LWO-2008-0056

**Management Summary of Enhanced Chemical Cleaning Conceptual Design**

Figure 1. ECC Process Diagram

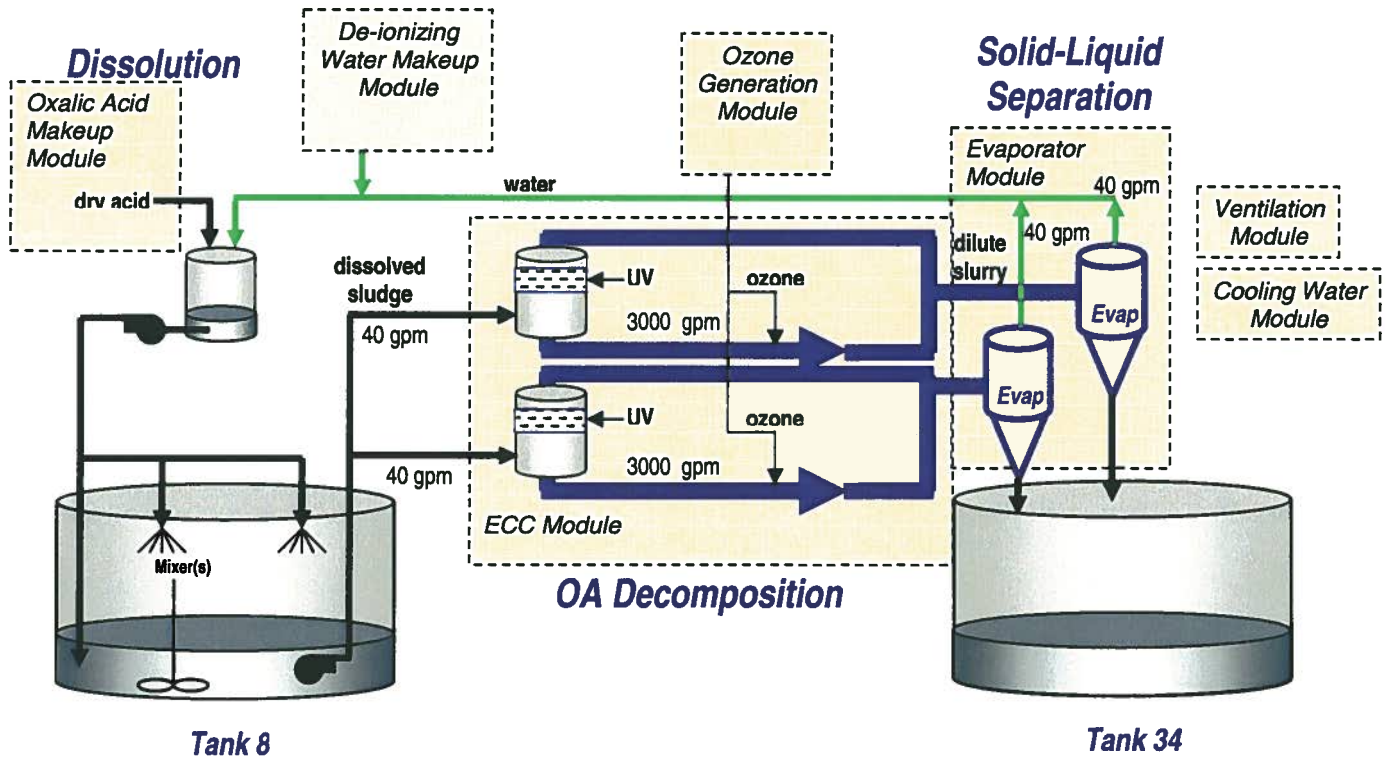
- *Managing the high flowrate through the ECC module.*  
Simulant testing is planned to incorporate the hazardous components of the sludge. This testing will include OA decomposition and evaporation. Identification of an appropriate scaled flow rate to be tested will be incorporated into the test planning.

- *Managing the size and weight of the evaporator.*  
Some of the size and weight concerns are impacts from shielding requirements. The inputs to the shielding calculations will be reviewed. The project currently carries an action to make sure that the tank heel sludge is washed to limit the Cs concentration. The flowsheet will be reviewed to look for opportunities to reduce the size of the unit operations. The desired result is to gravity feed the evaporator concentrate into the type III tank.

- *Identifying the path for reject water from the water makeup system.*  
Well water from SRS is processed through a de-ionizing water system to improve the purity. The reject stream must be incorporated into another water stream at SRS.

- *Managing the ozone*  
While managing ozone is a new activity in LWO, ozone/UV systems exist in industry to purify wastewater. Lessons learned from industry visits and studies will be incorporated into the project.
